The following amendments to drawings and specifications shall be incorporated into and forms part of the contract the same as if they had been written into the original.

END OF ADDENDUM NO. 1

JOB: 12169
INGONISH CIVIC BUILDING

1 BAG CUBBIES PLAN
ASK.01 1 : 50

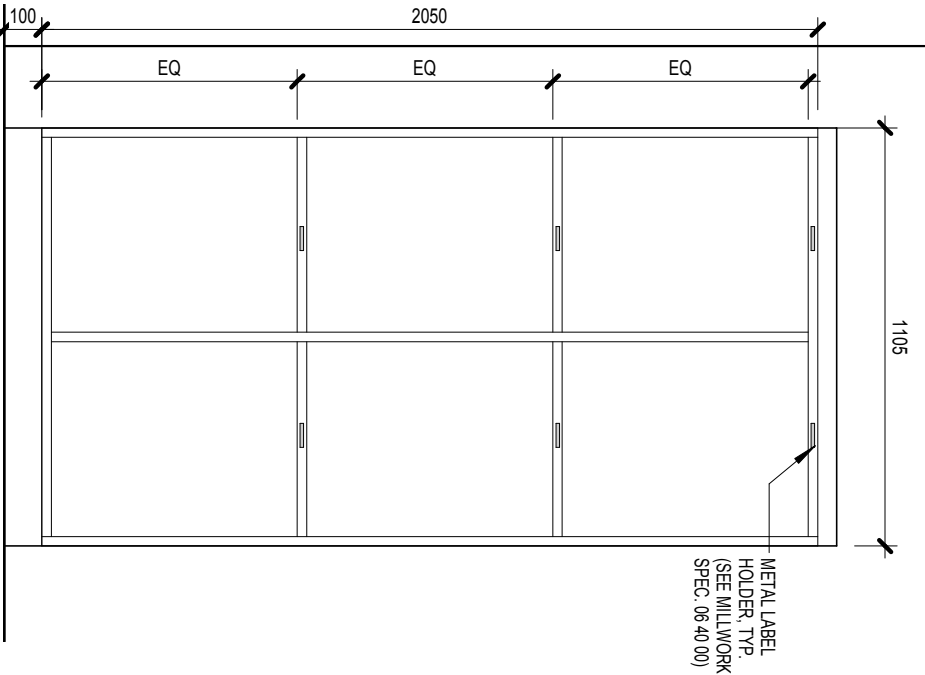
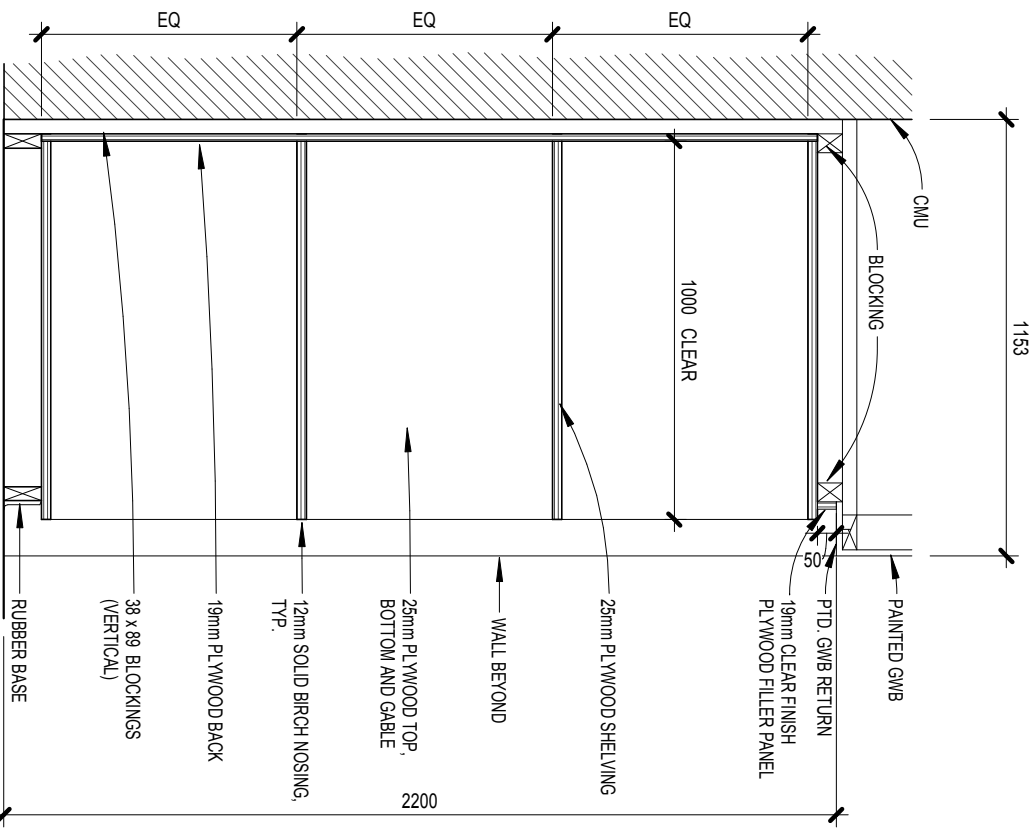
1. Refer to revisions to Bag Cubbies Details as illustrated on attached ASK.01
2. Refer to revisions to Gun Locker Details as illustrated on attached ASK.02

1 RCP MAIN BUILDING - ROOM 117
ASK.03 1 : 100

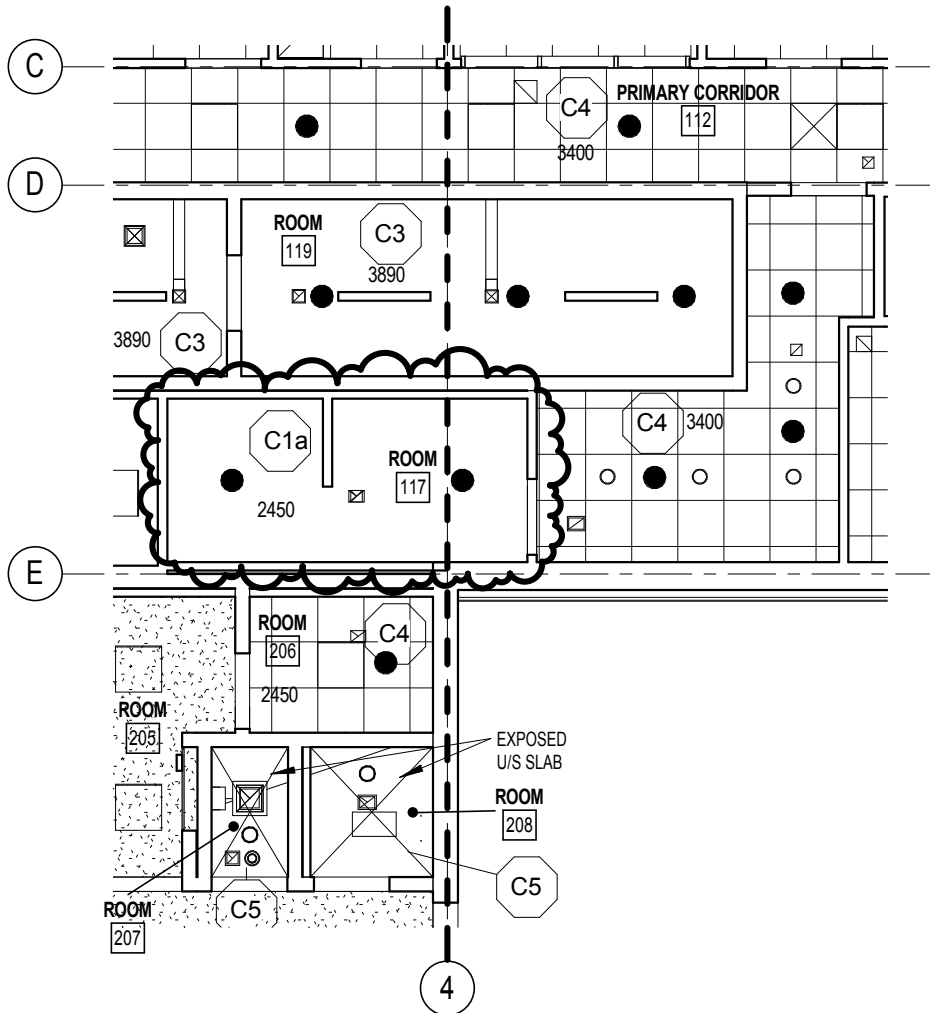
2. Detail 1: Add to note referencing Solid Steel Access Ladder: Provide Retractable Safety Post, Similar to Detail 2/204.
3. Refer to revision to Room 117 ceiling finishes as illustrated on attached ASK.03.

1. Add the following note to DOOR SCHEDULE: Recessed door contacts supplied by other. Door and frame contractor to provide 1" diameter hole at top of door and frame for contact insertion and wiring by the contractor and end devices supply and installed by others.
2. Revise ceiling finish noted for Room 117 in FINISH SCHEDULE to read: PTD GYP, WET RATED.

EXHAUST FAN EF-1, 2, 4, 5, 6 & 7 CONTROL SCHEMATIC

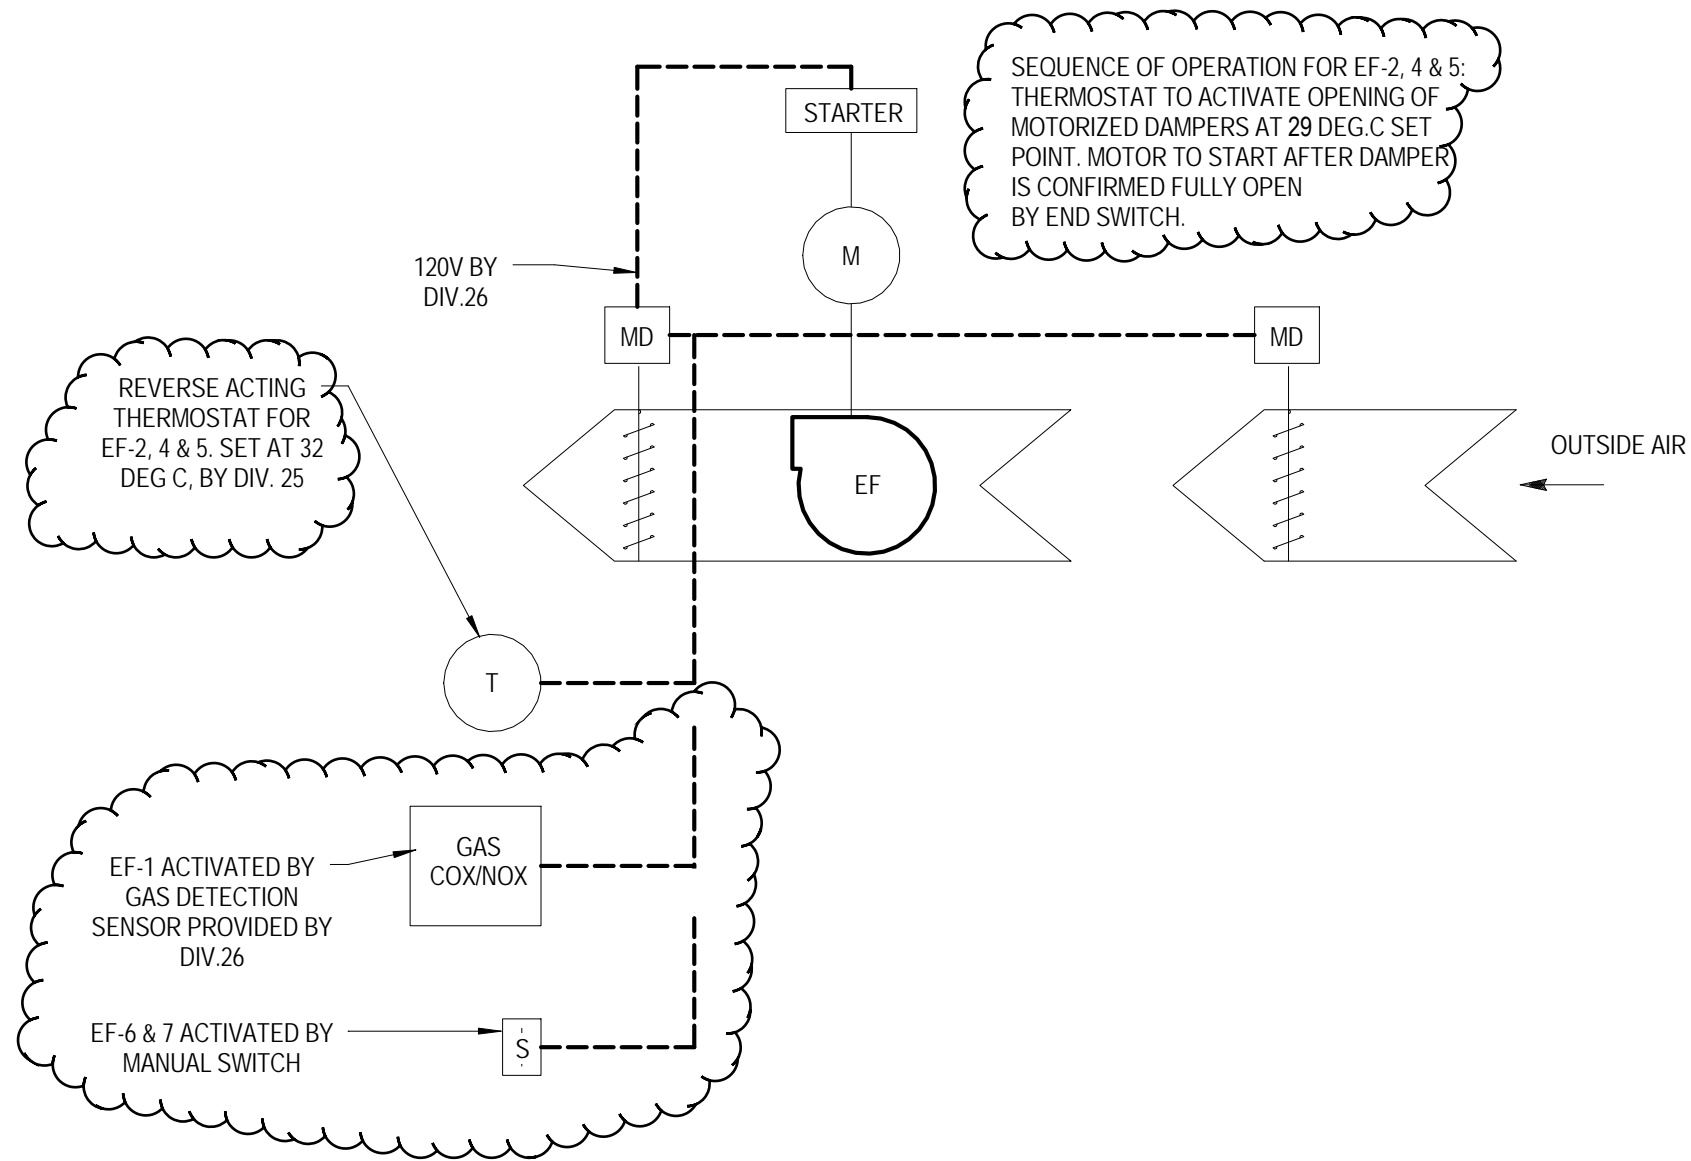
- .8 Drawing 425 CONTROLS**
 - .1 Refer to MSK-425-01, update detail 3/425.
 - .2 Refer to MSK-425-02, update detail 7/425.

6 SCHEMATIC - CONTACTOR 'C-1'
SCALE: N.T.S.

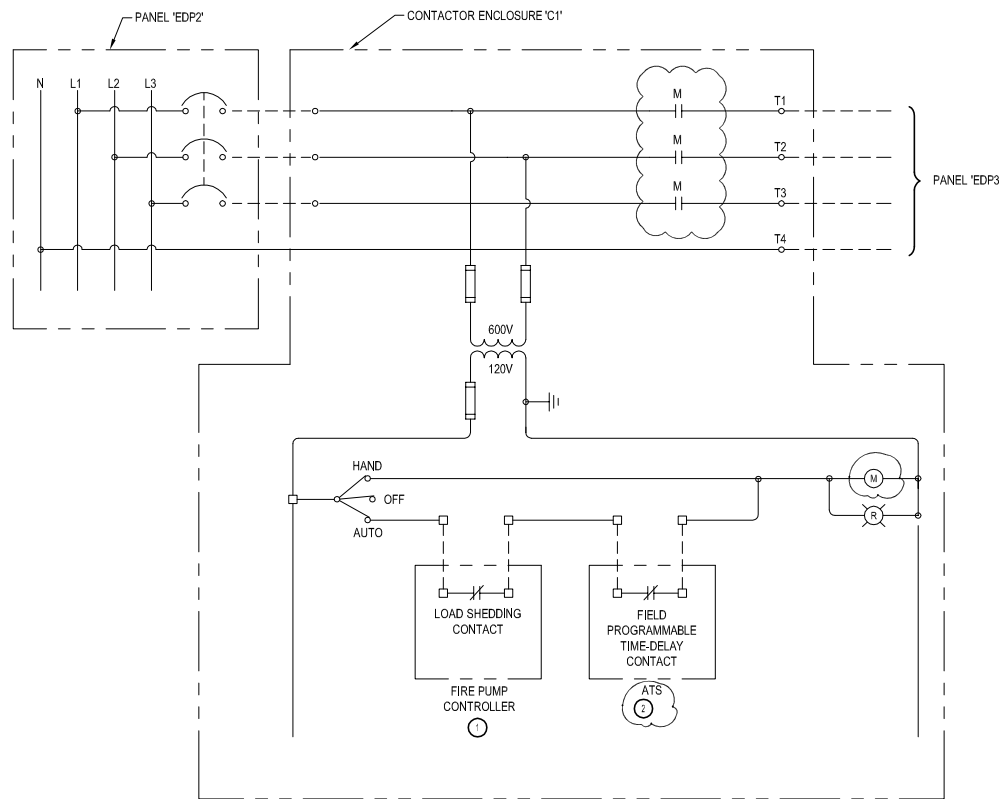
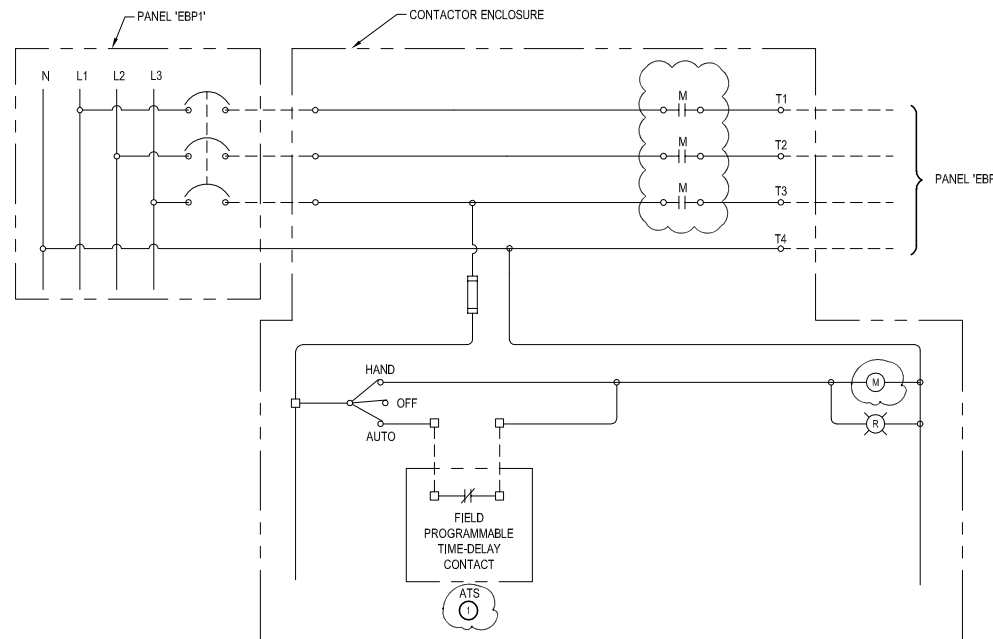
- .1 Schematic 6 & 7: Revise as per attached sketch ESK-01.

DIAGRAM - PARTIAL SINGLE LINE DIAGRAM
SCALE: N.T.S.

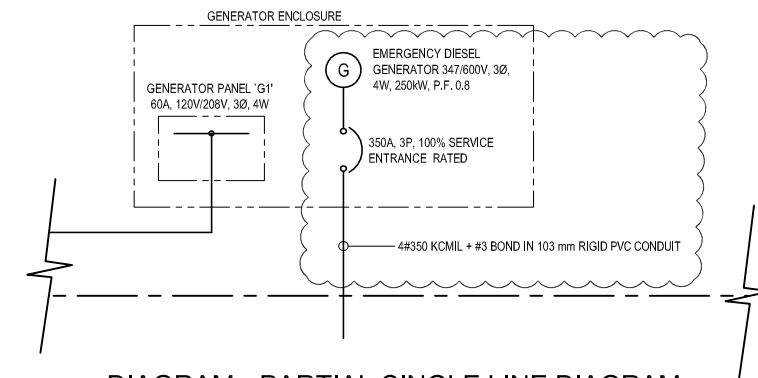
- .1 Interrupting capacity for panel EDP1 shall be minimum 14 KAIC minimum.
- .2 Revise generator size as per attached sketch ESK-01
